# Shoalhaven Starches Expansion Modification 23

Gas Fired Co-Generation Plant  
State Significant Development Modification Assessment  
(MP06\_0228-Mod-23)

April 2022

Published by the NSW Department of Planning and Environment

Figure 6 | Predicted Odour Concentrations (Mod 23 and Existing Factory)

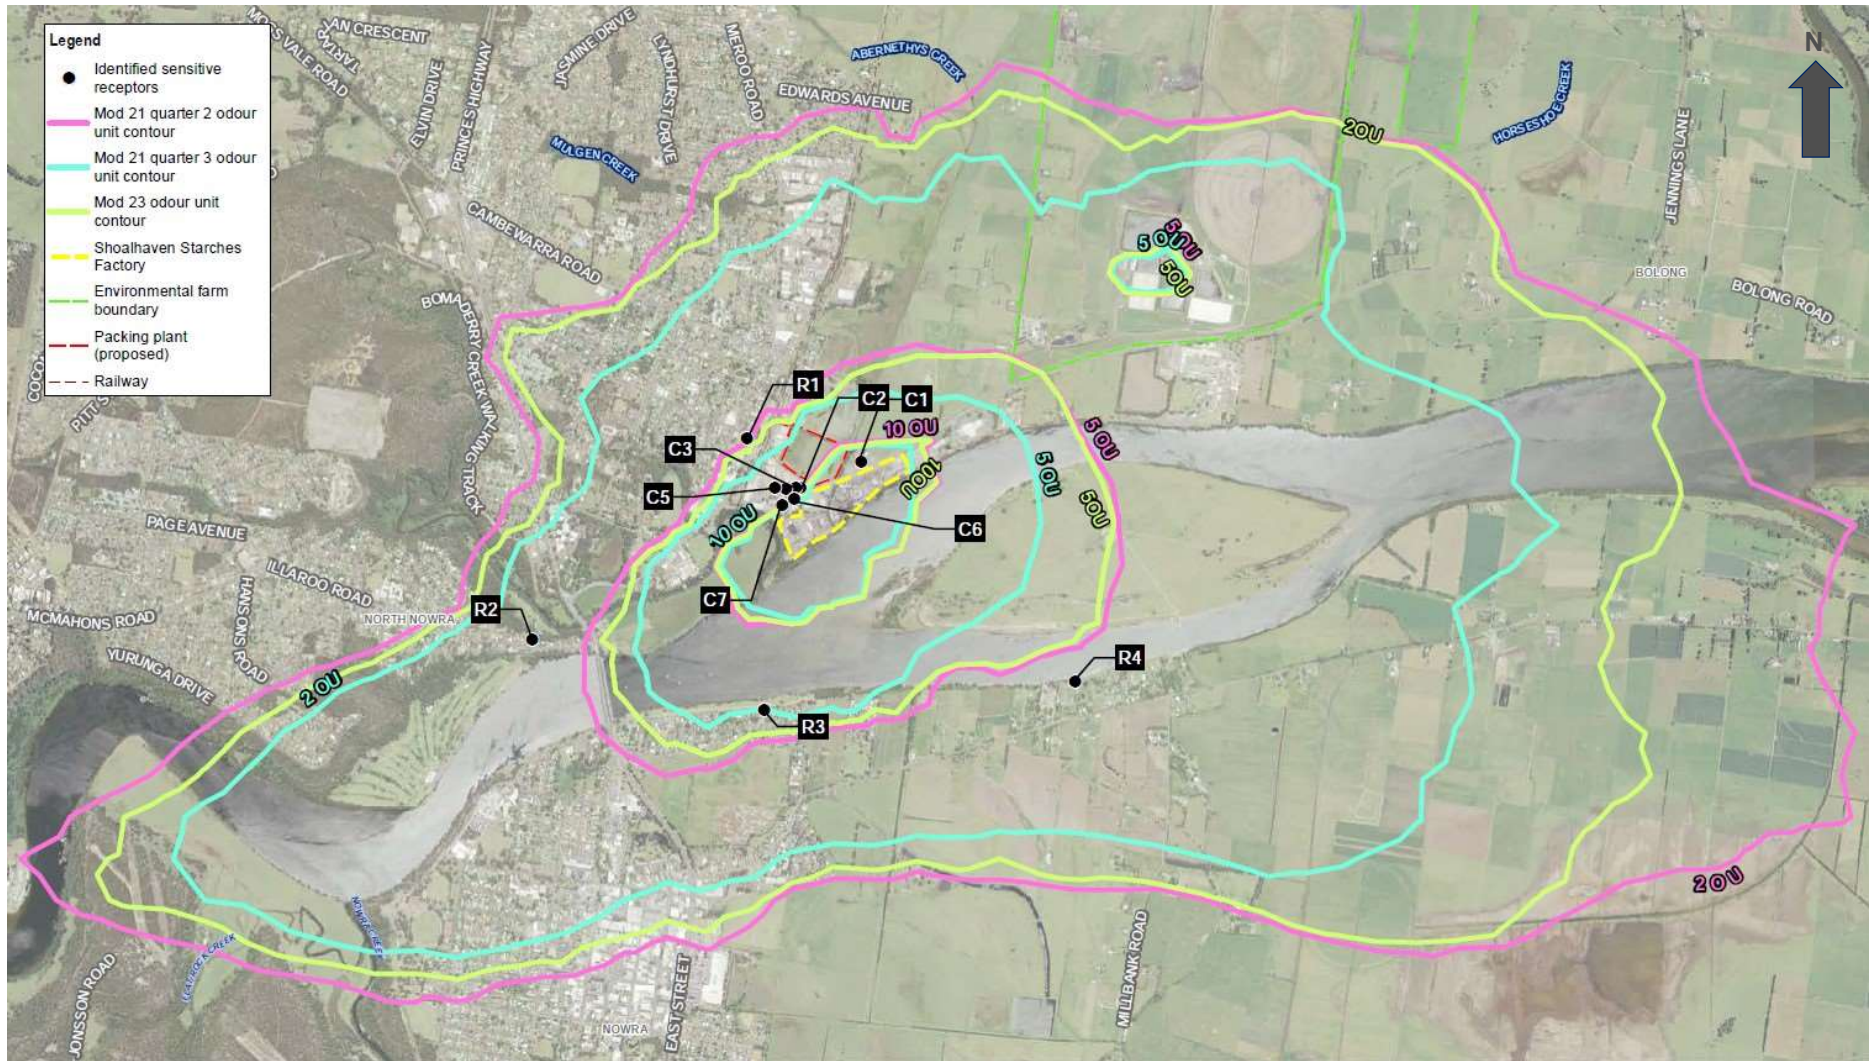
The AQA predicted odour concentrations at the nearest residential receivers would range between 3 – 5 odour units (OU) which is consistent with existing emissions from the factory. The predictions are consistent with the EPA's odour impact assessment criteria for residential areas, which ranges from 2 to 7 OU, depending on population density. There is expected to be a minor reduction in odour emissions due to the removal of coal and woodchips from use in the boilers. **Figure 6** shows the predicted odour contours for the modification (shown in green) compared with the approved factory, up to and including MOD 21 (pink and aqua show odour results from two different monitoring events).

Odour concentrations at commercial receivers were predicted to be above the EPA impact assessment criteria for residences, but consistent with odour concentrations from the existing factory. Odour at the nearest commercial receivers, located immediately adjacent to the factory, ranged from 7 to 12 OU. The AQA noted these levels would not cause significant odour impacts, given the industrial nature of the receivers.

In relation to odour, the consent requires quarterly monitoring of key emission sources at the factory and an annual odour audit. Given the minimal change in odour emissions due to the modification, no further conditions are required to manage odour.
